WestConnex

M4 East

Submissions Report

Appendices

Figure 2.3 Reconfigured Homebush Bay Drive interchange (oblique elevation, facing west)

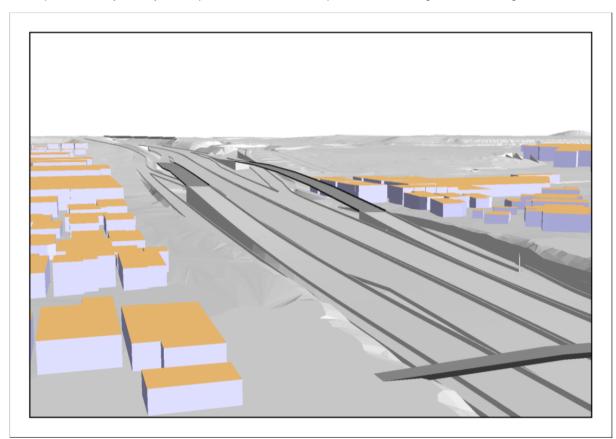
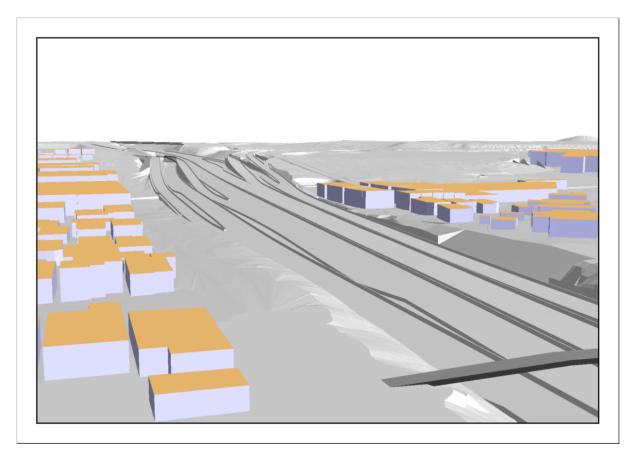
The below sections outline the proposed changes to the configuration of this interchange. The new arrangement is shown in **Figure 2.3** as an oblique elevation and in **Figure 2.4** in plan view.

The proposed re-routed cycleway would travel under the Homebush Bay Drive on-ramp via an underpass, rather than an overpass as described in the EIS. The off-road section of the re-routed eastbound cycleway has been shortened, and would connect back into the M4 shoulder on the eastbound Homebush Bay Drive on-ramp connection to the surface M4 about 150 metres east of the underpass. The cycleway underpass would be developed further during detailed design.

Figure 2.7 Reconfigured Wattle Street (City West Link) interchange

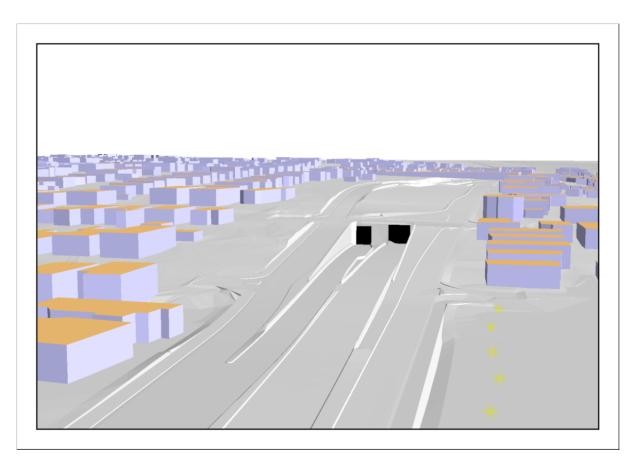
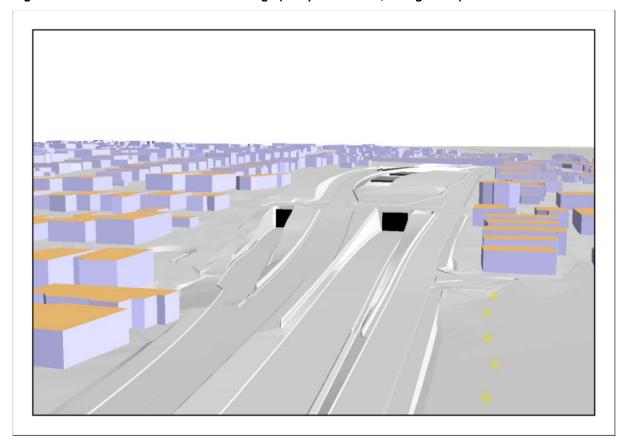
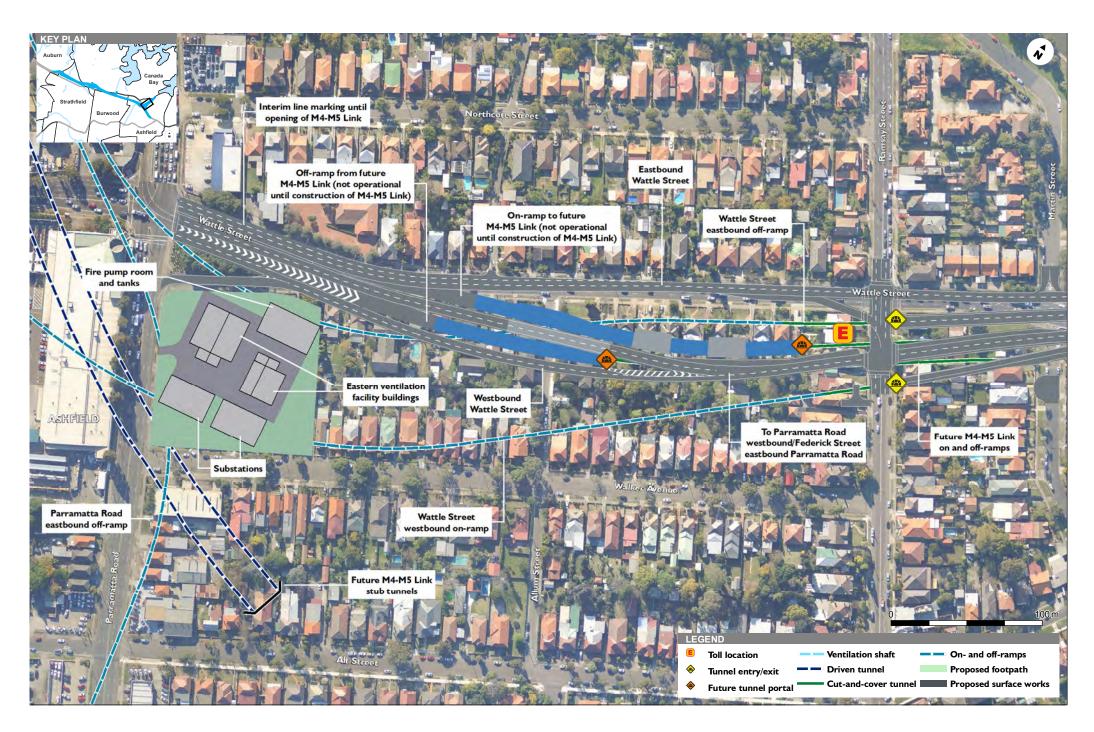
In the EIS, the Wattle Street (City West Link) interchange included separate cut and cover tunnel structures. The interchange as described in the EIS is depicted in **Figure 2.5** as an oblique elevation.

The below sections outline the proposed changes to the configuration of the interchange. The new arrangement is shown in **Figure 2.6** as an oblique elevation and in plan view in **Figure 2.7**.

A cul-de-sac would be established at Martin Street abutting the eastern side of the project.

Figure 2.1 Reconfigured Wattle Street (City West Link) interchange

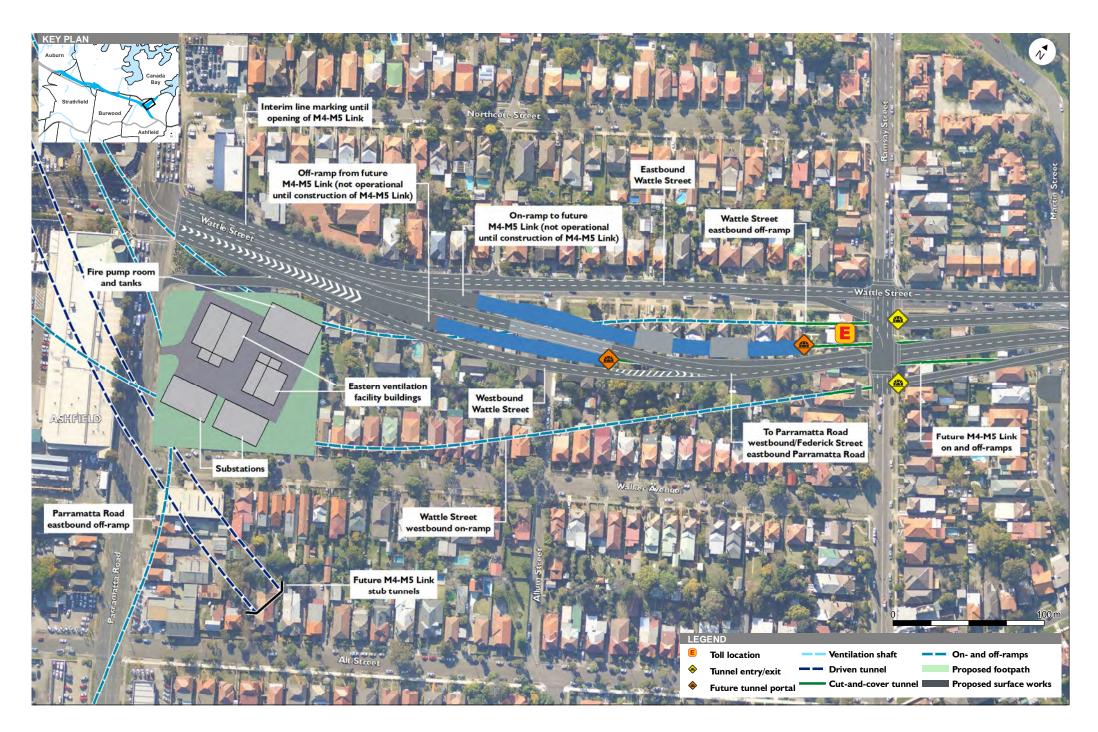
The below sections outline the proposed changes to the configuration of the interchange. The new arrangement is shown in **Figure 2.1.**

The M4-M5 Link cut and cover structures would start in about the same location as described in the EIS, but would be realigned so that they are positioned between the M4 East on- and off-ramps. The on- ramp dive structure would be lengthened, while the off-ramp dive structure would be shortened.

Figure 4.2 Noise model view - design change at Wattle Street interchange

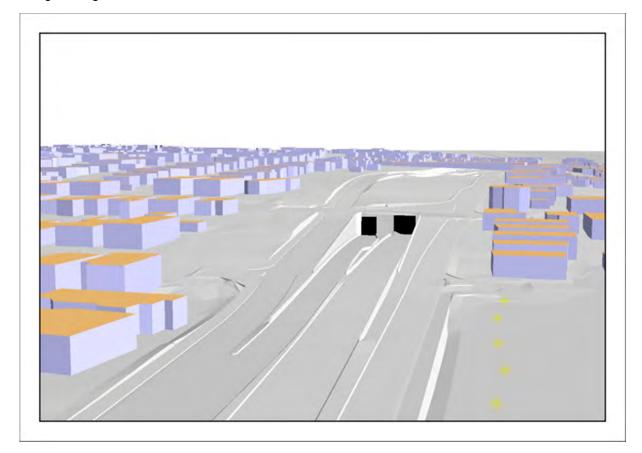
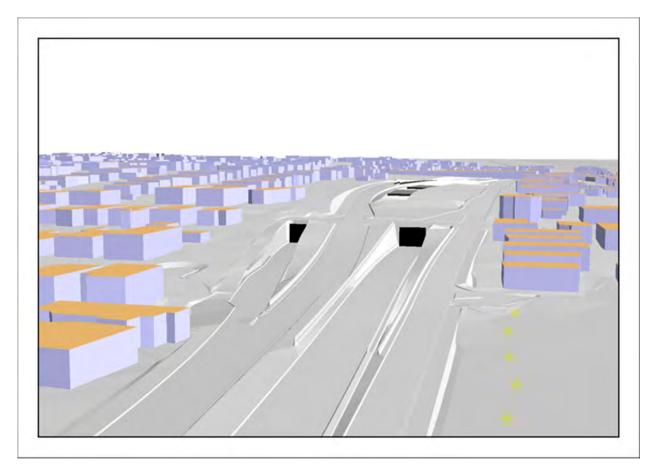
Views of the three dimensional noise models are presented in **Figure 4.1** and **Figure 4.2** for the EIS design and design change at Wattle Street respectively. Refer to **Section 2** for a description of the design change.

Figure 2.3 Reconfigured Homebush Bay Drive interchange (oblique elevation, facing west)

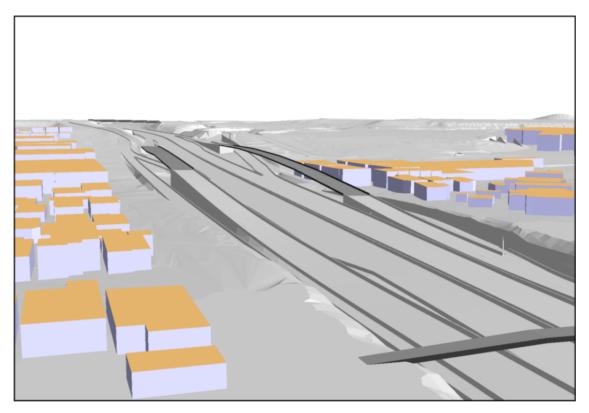
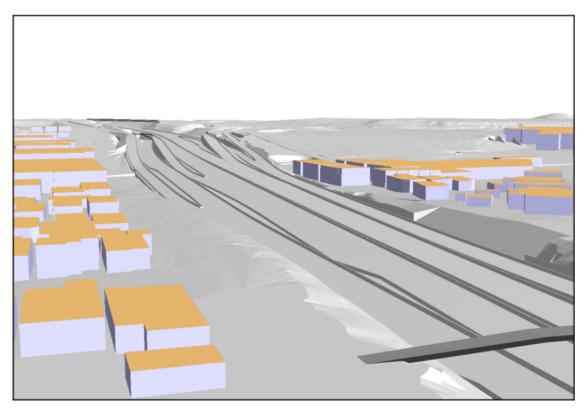
To maintain eastbound access to the existing M4 from Homebush Bay Drive, the design described in the EIS incorporated the construction of an elevated bridge up to eight metres in height adjacent to apartments on Verley Drive. The interchange as described in the EIS is depicted in **Figure 2.2** as an oblique elevation.

The below sections outline the proposed changes to the configuration of this interchange. The new arrangement is shown in **Figure 2.3** as an oblique elevation and **Figure 2.4** in plan view. An indicative view of the revised interchange is shown in **Figure 2.5**.

Traffic from the Homebush Bay Drive on-ramp choosing to use the eastbound mainline tunnel would travel in the southern-most (inside) lane, over the cycleway underpass, then on the short bridge described above (over eastbound surface M4 traffic) to merge with traffic travelling from the existing M4 east of Saleyards Creek. The design of the on-ramp widens to two lanes for managed motorway storage, before tapering back to one lane prior to merging with traffic travelling from the existing M4.

Figure 2.8 Reconfigured Wattle Street (City West Link) interchange

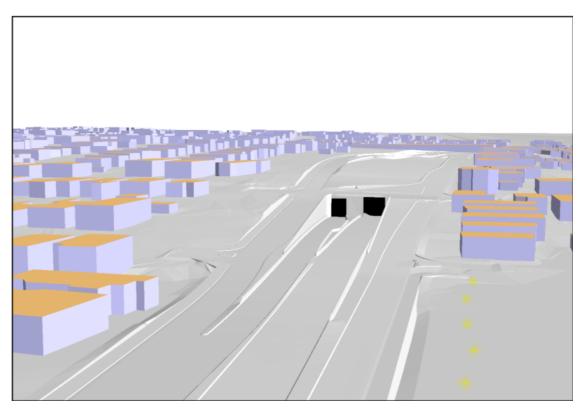
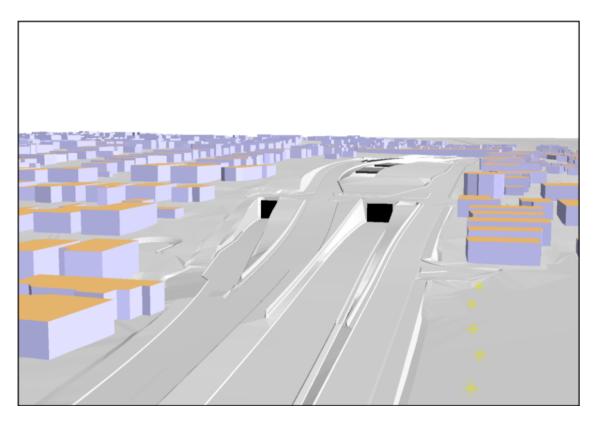
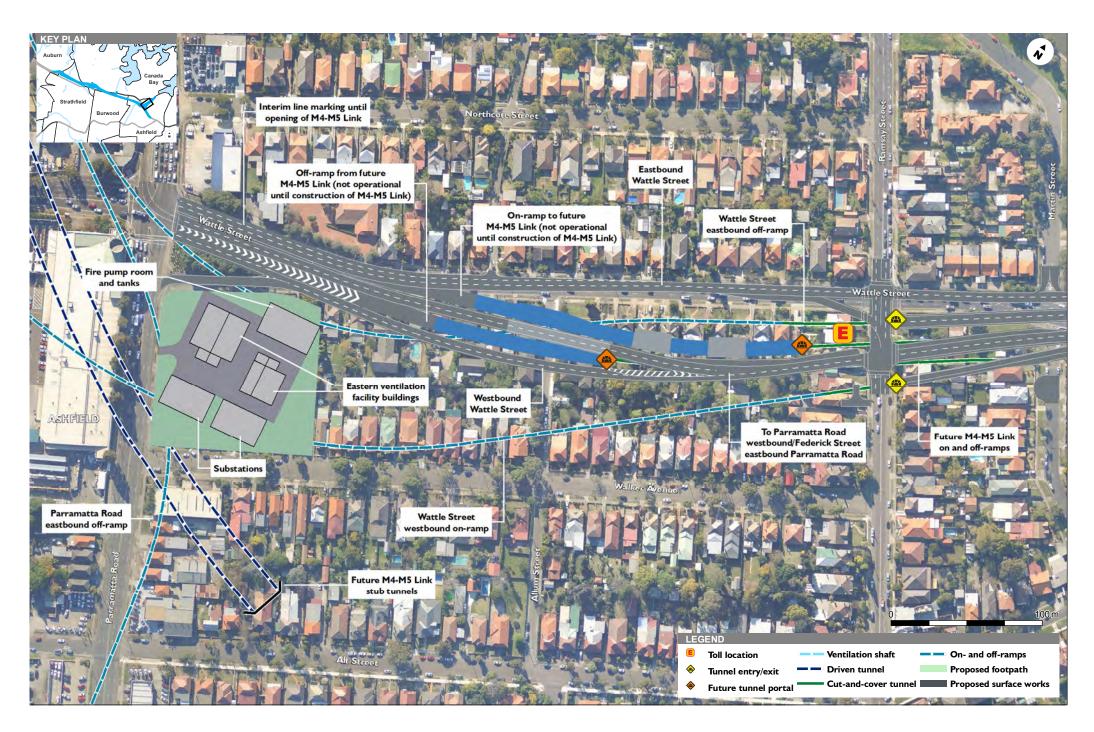
In the EIS, the Wattle Street (City West Link) interchange included separate cut and cover tunnel structures. The interchange as described in the EIS is depicted in **Figure 2.6** as an oblique elevation.

The below sections outline the proposed changes to the configuration of the interchange. The new arrangement is shown in **Figure 2.7** as an oblique elevation and **Figure 2.8** in plan view. An indicative view of the revised interchange is shown in **Figure 2.9**. There would also be changes to subsurface property acquisition.

Alternative access to Wattle Street would be available via Alt Street and Ramsay Street/Waratah Street. As the on-ramp for the M4 East tunnel entrance from Wattle Street would start on the northern side of Martin Street, access to the M4 East tunnel entrance would be via the intersection of Waratah Street and Wattle Street.

Figure 2.3 Reconfigured Wattle Street (City West Link) interchange

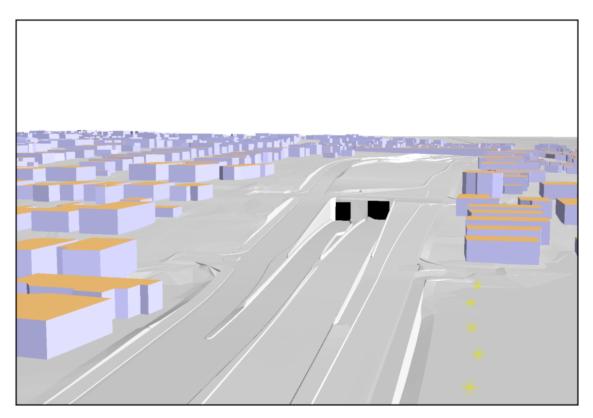
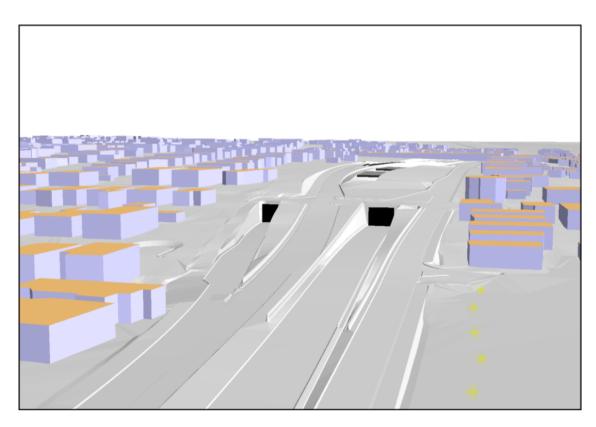
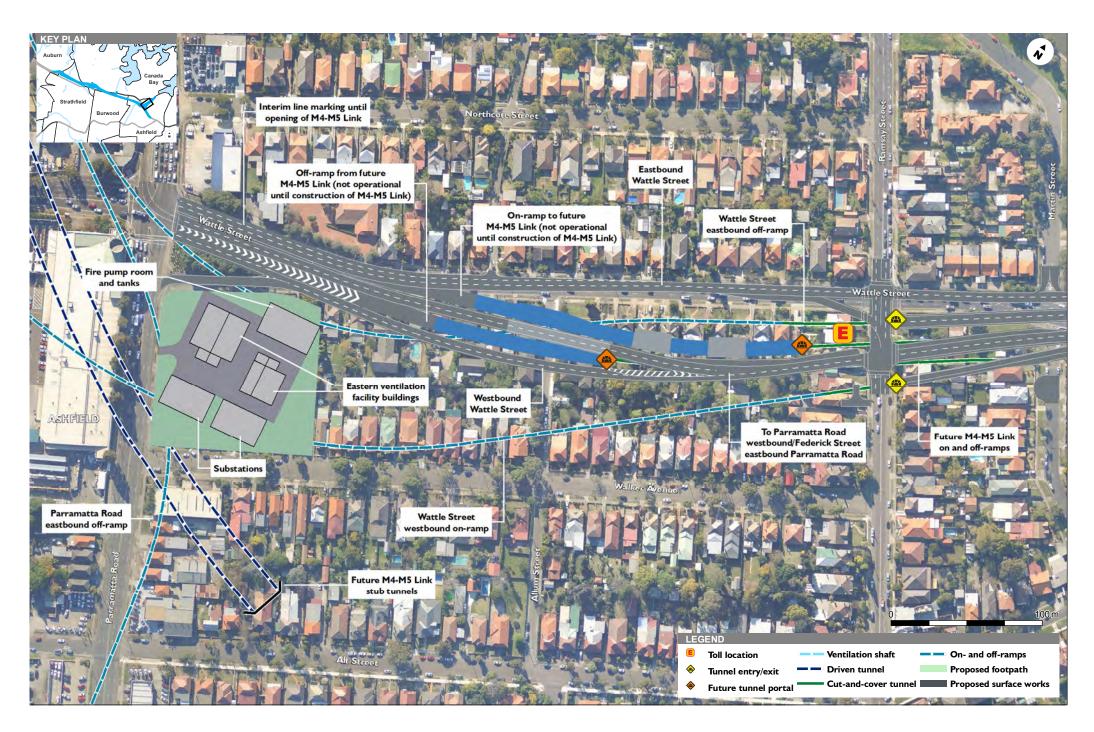
In the EIS, the Wattle Street (City West Link) interchange included separate cut and cover tunnel structures. The interchange as described in the EIS is depicted in **Figure 2.1** as an oblique elevation.

The below sections outline the proposed changes to the configuration of the interchange. The new arrangement is shown in **Figure 2.2** as an oblique elevation and **Figure 2.3** in plan view. An indicative view of the revised interchange is shown in **Figure 2.4**.

This amendment would create a cul-de-sac and an adjacent area of residual land at the northern end of Martin Street which would create additional area for landscape/ screen planting in this portion of the project.

Figure 2.6 Reconfigured Homebush Bay Drive interchange (oblique elevation, facing west)

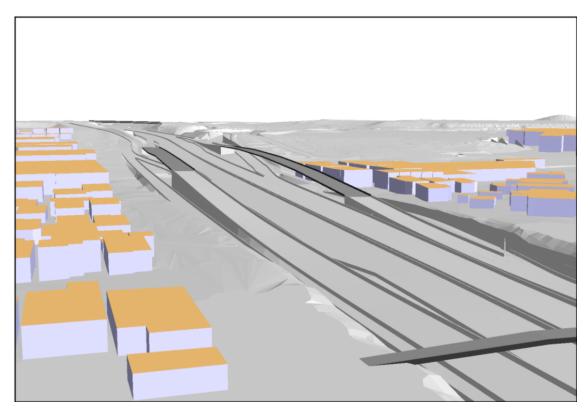
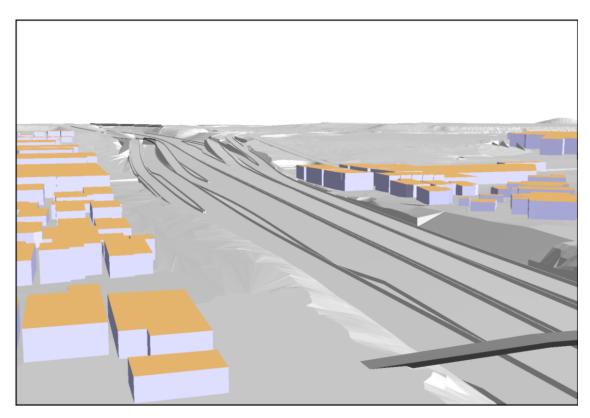
To maintain eastbound access to the existing M4 from Homebush Bay Drive, the design described in the EIS incorporated the construction of an elevated bridge up to eight metres in height adjacent to apartments on Verley Drive. The interchange as described in the EIS is depicted in **Figure 2.5** as an oblique elevation.

The below sections outline the proposed changes to the configuration of this interchange. The new arrangement is shown in **Figure 2.6** as an oblique elevation and **Figure 2.7** in plan view. An indicative view of the revised interchange is shown in **Figure 2.8**.

Traffic from the Homebush Bay Drive on-ramp choosing to use the eastbound mainline tunnel would travel in the southern-most (inside) lane, over the cycleway underpass, then on the short bridge described above (over eastbound surface M4 traffic) to merge with traffic travelling from the existing M4 east of Saleyards Creek. The design of the on-ramp widens to two lanes for managed motorway storage, before tapering back to one lane prior to merging with traffic travelling from the existing M4.

Figure 2.9 Change in orientation of Sydney Street substation

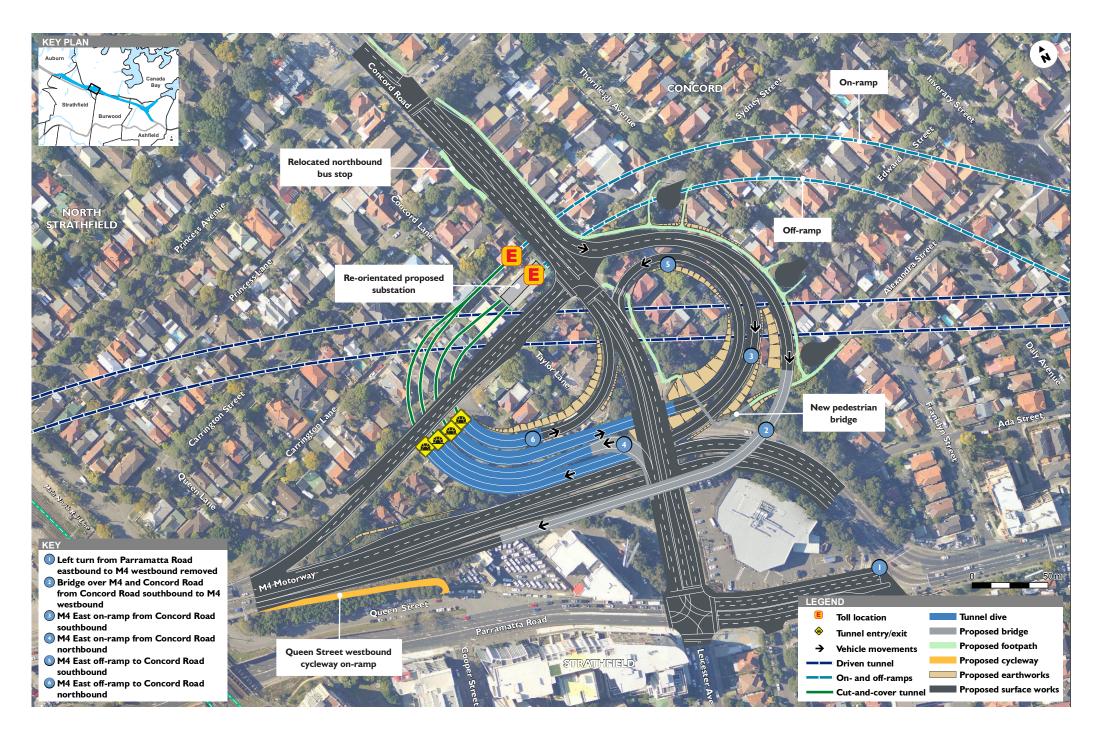
The proposed orientation of the substation is shown in **Figure 2.9**, and an indicative view of the re-oriented substation is provided in **Figure 2.10**.

Figure 2.1 Reconfigured Wattle Street (City West Link) interchange

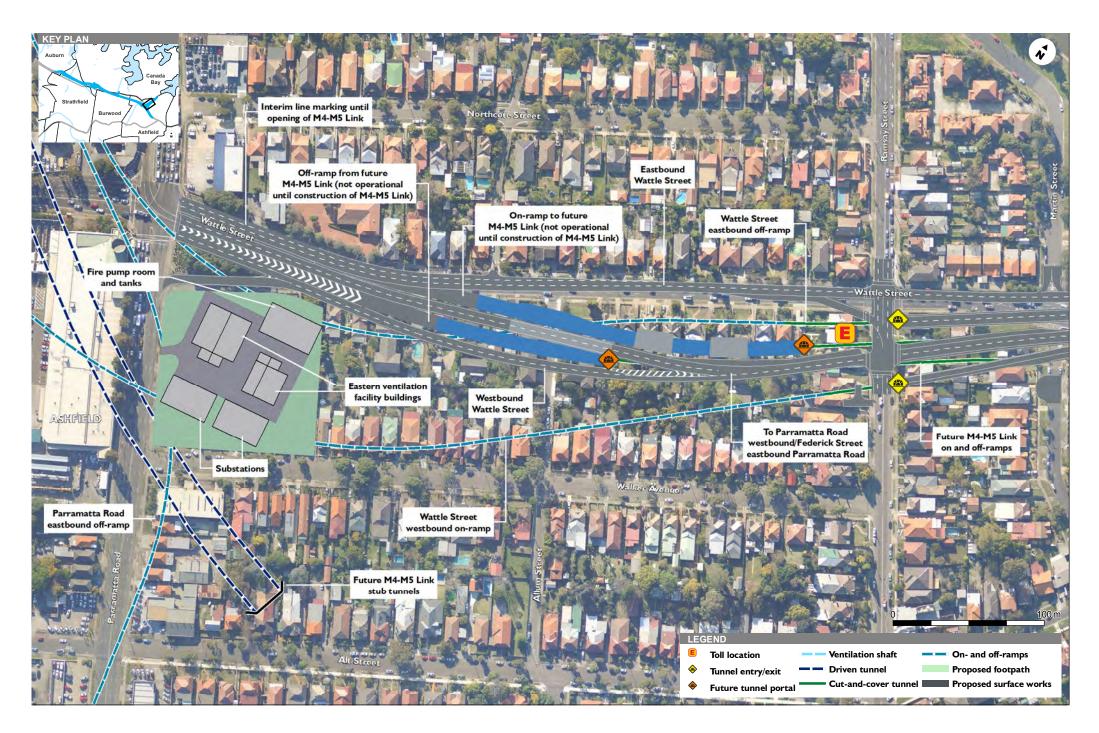
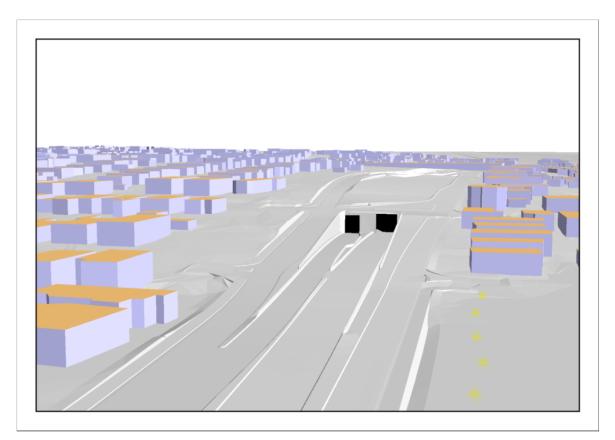
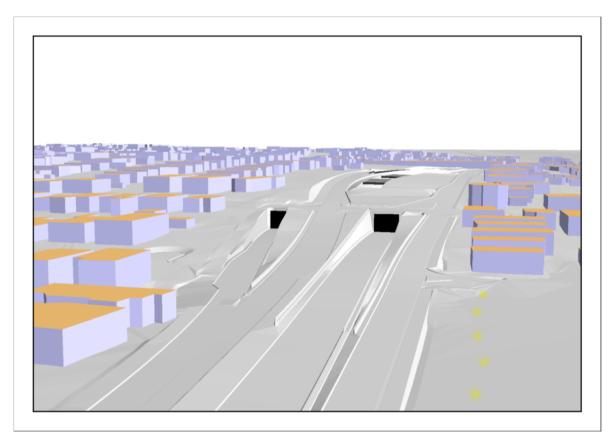
The below sections outline the proposed changes to the configuration of the interchange. The new arrangement is shown in plan view in **Figure 2.1. Figure 2.2** shows the original configuration in oblique view and **Figure 2.3** shows the revised configuration in oblique view.

A cul-de-sac would be established at Martin Street abutting the eastern side of the project.
